# Bel Marin Keys Unit V Expansion of the Hamilton Wetland Restoration Project

### **Responses to Comments**

# Final Supplemental Environmental Impact Report/Environmental Impact Statement

#### SCH# 1998031053

Figure 4-8 Schematic of Habitats by Tide Levels

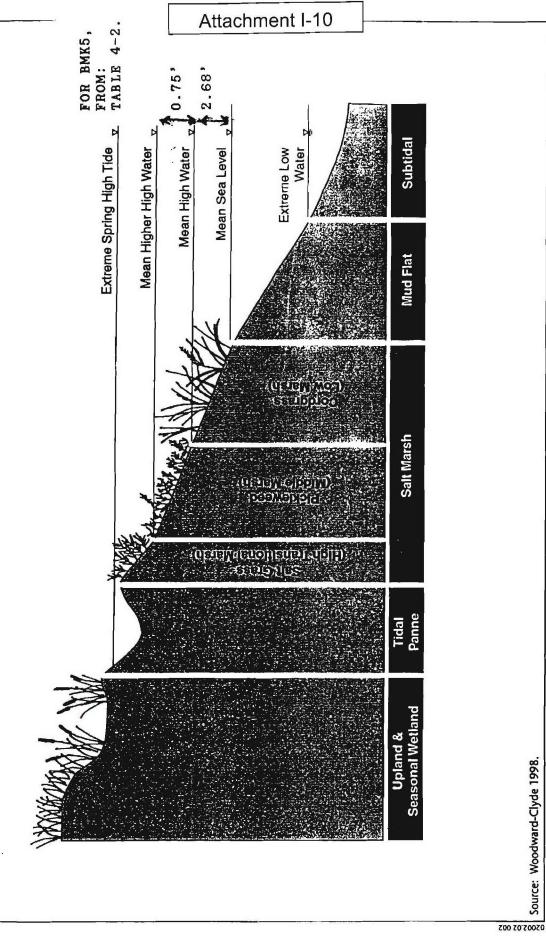
To establish TSM on the whole 849 acres would require the entire area to reach equilibrium, with tidal action and after settling, as tilted planes at the right elevation and each plane with no more than 3.43' change in elevation to include both Low and Middle TSM. (See above Table and Figure 4-8, included on next page, pg 3.) Large depressions must also be absent because ponded salt water will not yield the desired habitat. In the FEIR please explain how all 849 acres could be expected to form "tidal marsh" with the above constraints.

If documented evidence does not support the project restoration scenario, then I propose that a more likely scenario: tidal erosion and silt deposition will establish an "equilibrium length" (EL) of TSM perpendicular to any existing or new levee. (See Figure 4-8, next page, pg 3.) EL can be determined if it is not known or published. Any tidal area beyond the EL limit will not be TSM habitat, it will be mud-flats.

If the above more likely TSM scenario is correct, decreasing the amount of tidal area will not necessarily decrease the area of TSM because it is more dependent on levee length than tidal area. Please take this into account when evaluating the merits of the alternatives and the "Mid-1800's shoreline" Alternative in the FEIR/S, see Section III.

As noted in the response to Comment I-10.2, the alternative marsh formation scenario is not likely to result in the same amount of tidal marsh on the site, and thus would not meet the project's goal and objectives.

1) As noted in response to Comment I-10.2, the commenter's suggested alternative marsh formation scenario makes no provision for conditions favorable to natural sedimentation to achieve marsh elevations. The alternative mentions no specifics regarding lowering of outboard levees, internal peninsulas, breaches, or other details. Thus, it is speculative to assert that it would result in the same tidal salt marsh as Alternatives 1 and 2 or not.

Figure 5.B-1
Wildlife Preserves and Other Sensitive
Areas Surrounding the Project Site

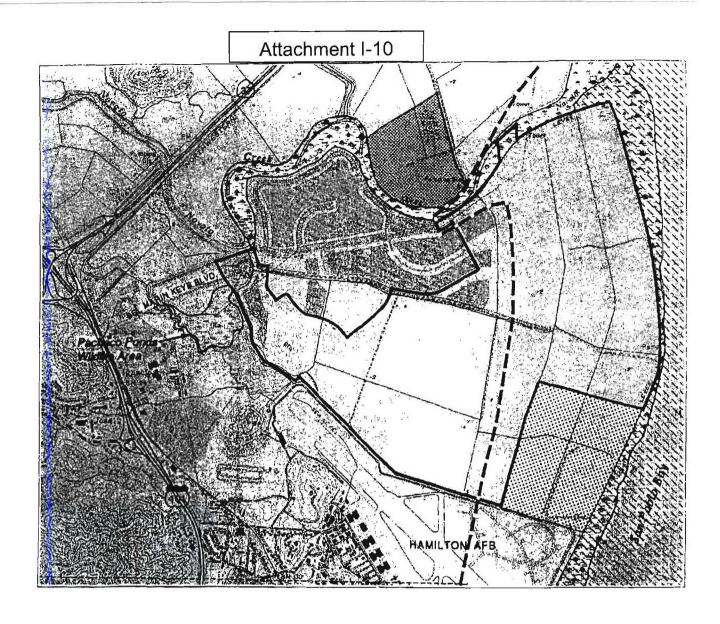
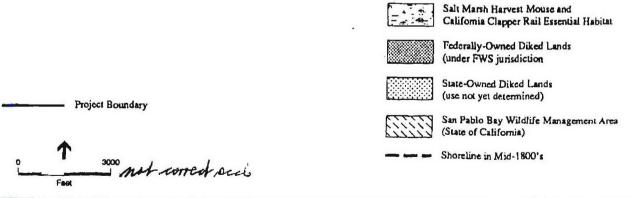
In the FEIR/S please reevaluate the mid-1800's shoreline alternative described above using the information developed from Section I. Please also discuss the following advantages of placing the new outboard levee at the mid-1800's shoreline location:

- May provide esentially the same tidal salt marsh area as Alternatives 1&2. See Section I.
- 2. Provide the BMK4 300-acres F-2 ponding requirement.
- 3. Provide additional area to expand ponding for the Pacheco Pond overflow to provide additional flood control for the City of Novato if necessary.

- 4. Allow economic agriculture in the summer (see Policy A-6, Consistency Analysis, pg 4.16 of FEIR/EIS.) to satisfy the CWP. (A-1.6 & EQ-2.58)
- 5. Provide expanded area for diversity of habitat (CWP EQ-2.58)
- 6. Provide agriculture to meet BCDC Policy 1, pg 6 and Policy 2, pg 4 of BCDC Diked Historic Baylands of S.F. Bay.
- 7. Provide wetlands area equivalent to the mid-1800's.
- 3. Preserve the 151 acres agricultural wetlands with "no-net loss" of wetlands. (See pg 3-13, Exec. Sum.)
- 10. Preserve the 114 acres seasonal wetlands in the borrow pit area.
- 11. Reduce the visual impact of the outboard levee on BMK residents.
- 12. Reduced noise level in BMK during construction.
- 13. Mitigate Signifigant Impacts BIO-6, BIO-7, BIO -20.

In the FEIR/S, please address Policy EQ-2.49. In view of Policy EQ-2.49 and the results of the Alternative 5 reevaluation in III above, show justification for tidal restoration in excess of the shoreline boundary in the mid-1800's, as shown on Fig. 5,B-1 of the BMK5.
